Laurel Hill  
Conditional  
Use PUD

# PLANNED UNIT DEVELOPMENT

# LAUREL HILL SAM'S POINT ROAD BEAUFORT COUNTY, SOUTH CAROLINA

AS APPROVED BY THE BEAUFORT COUNTY DEVELOPMENT REVIEW TEAM  
OCTOBER 15, 1997

**EXHIBIT N.**

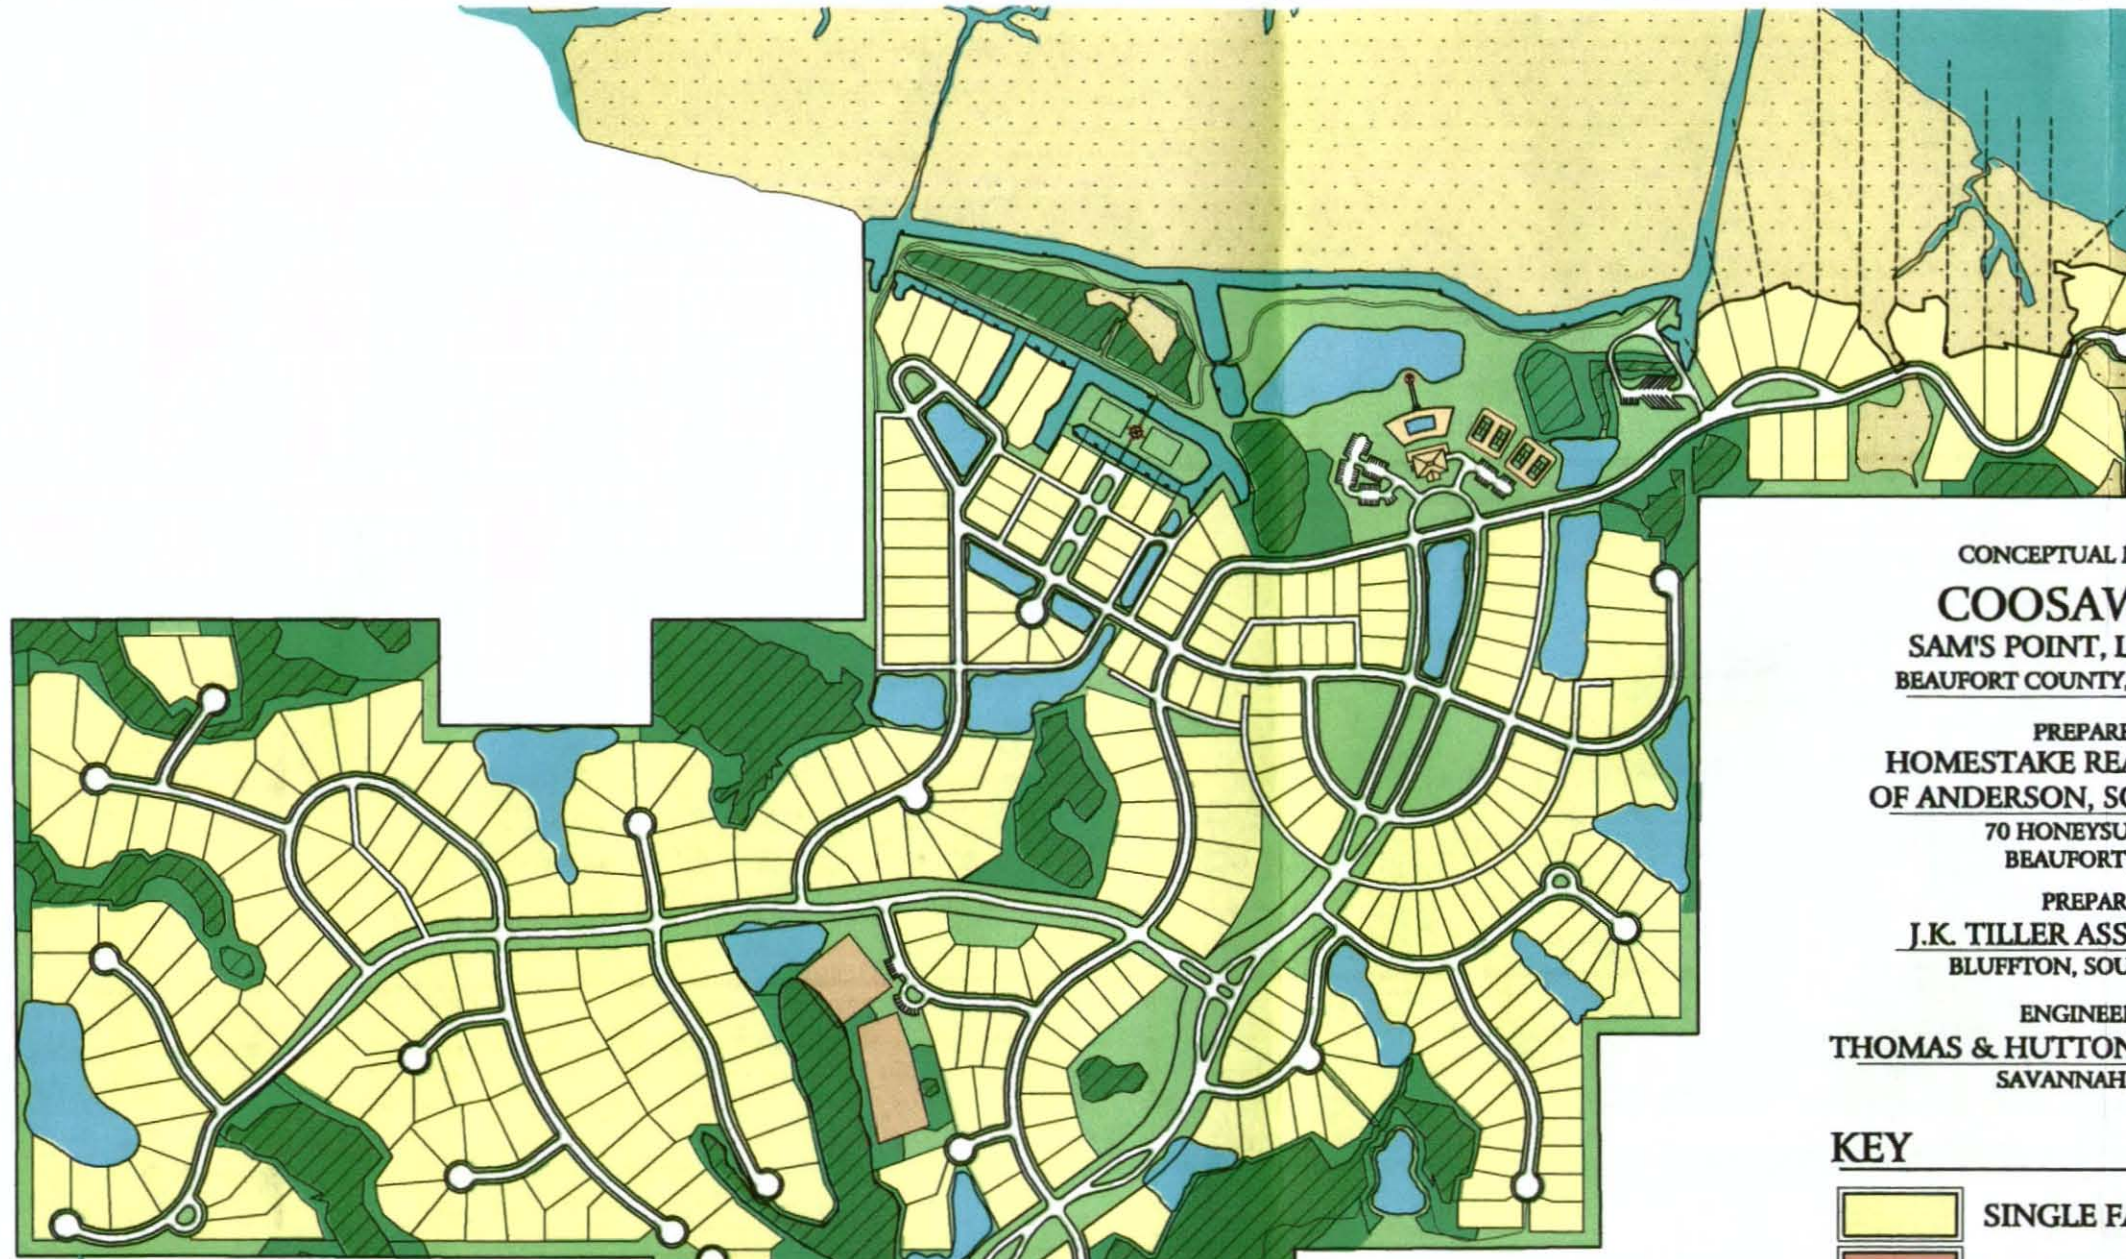
We have reviewed the proposed water master plan for Laurel Hill and offer the following:

- The water line along Sam's Point Rd. is a 10" line (not a 12").
- The hydraulic model should be re-run with a 10" line on Sam's Point Rd. to verify your internal line sizes. Please let us know the results of the revised model.

In regards to sewer, since sewer service is not currently available to the property, the Authority does not object to the use of on-site septic tanks. If you have any questions or need more information, please give me a call.
